802.3dj D1.2

Comment Resolution

Logic Track

Figure 177-10—Inner FEC pad detection state diagram

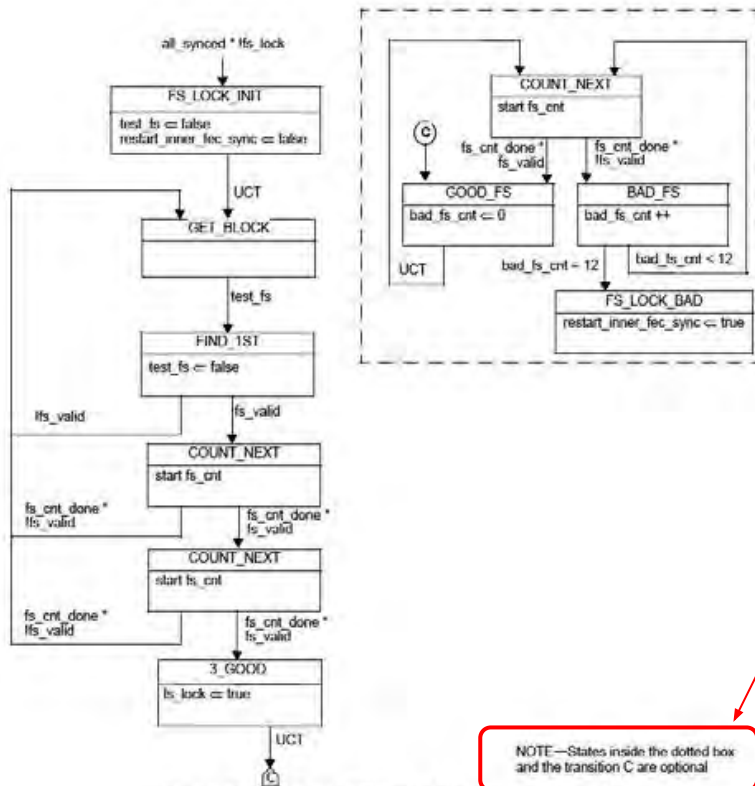
The dotted box continuously checks for valid frame sequence payloads at the correct location after the initial fs_lock is set in state 3_GOOD.

Why optional? Why not make it mandatory?

Editors recommendation: ACCEPT IN PRINCIPLE.
Pending task force discussion.

Figure 177-9—Inner FEC self-synchronization state diagram

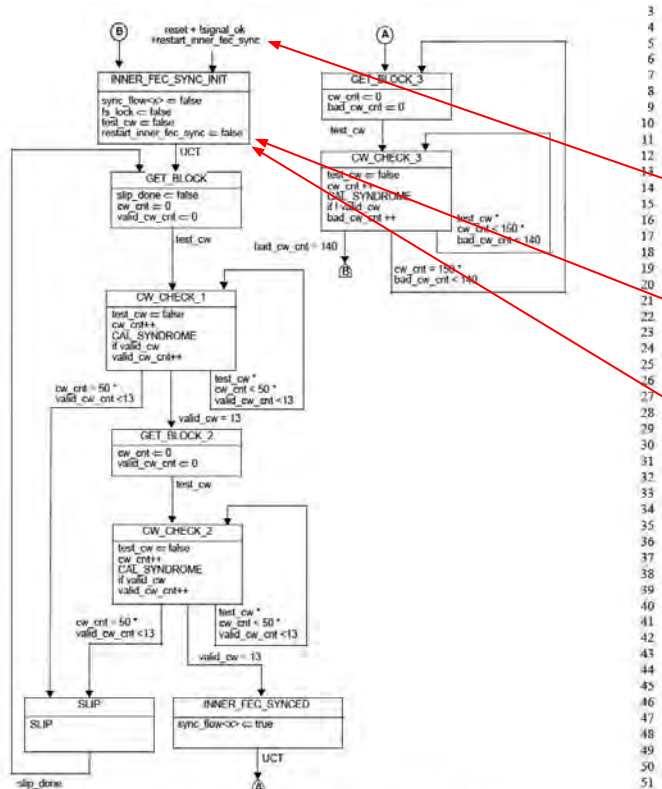
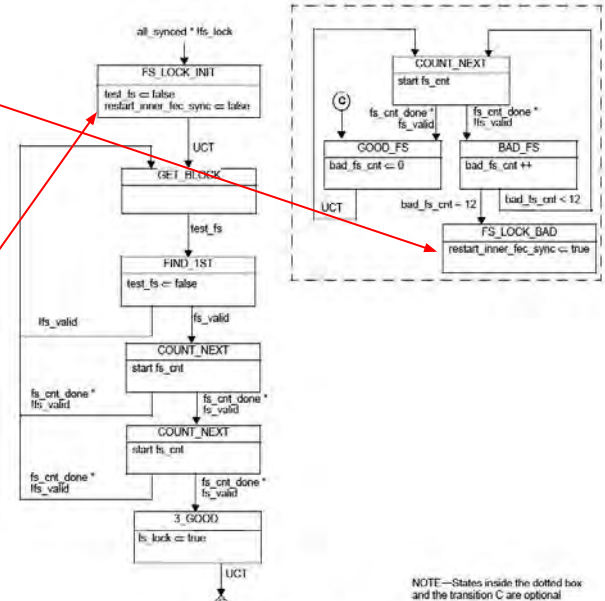
restart_inner_fec_sync is set true in FS_LOCK_BAD state

It forces Fig. 177-9 to restart. Note there are 8 of these, one per inner fec flow.

restart_inner_fec_sync is reset in two (actually 9) places.

Suggested remedy is to remove the reset (set to false) in INNER_FEC_SYNC_INIT.

Reset of fs_lock in INNER_FEC_SYNC_INIT should cause Fig.177-10 to go to FS_LOCK_INIT, but only after all 8 flows again achieve sync and all_synced is true. However, this won't happen immediately and Fig. 177-9 gets stuck in INNER_FEC_SYNC_INIT state.

Editors recommendation: ACCEPT IN PRINCIPLE.
Implement suggested remedy with editorial license
